33520B-02

Modification Recommended Service Note

33520B Function Generator

Serial Numbers: MY000000000 to MY57600600 and SG000000000 to SG57600600

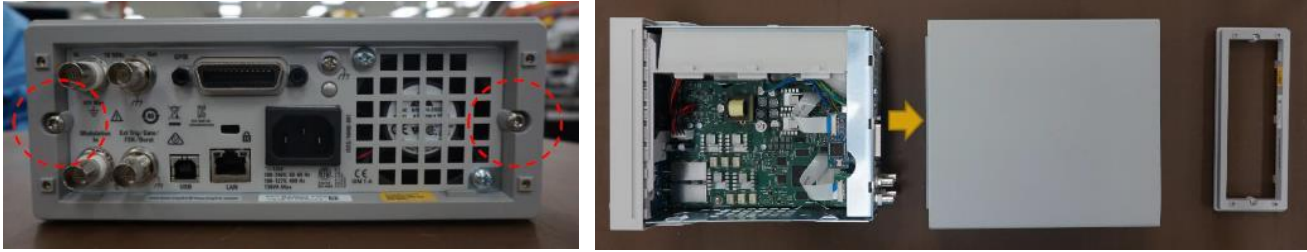
The Problem – Some customers have reported that, when line power is applied to the instrument but the instrument is NOT turned on (“Standby Mode”), some instruments will emit an audible high-pitched whistle or whine. To fix this, the existing power supply must be replaced with a newly designed power supply, as detailed in the solution below.

The solution is to replace the old power supply with a new one. The old power supply was manufactured by XP Power. The new power supply is manufactured by MeanWell, and has Part Number 0950-6082.

Old Noisy XP Power Supply (PN xxxx-xxxx)

New MeanWell Power Supply (PN 0950-6082)
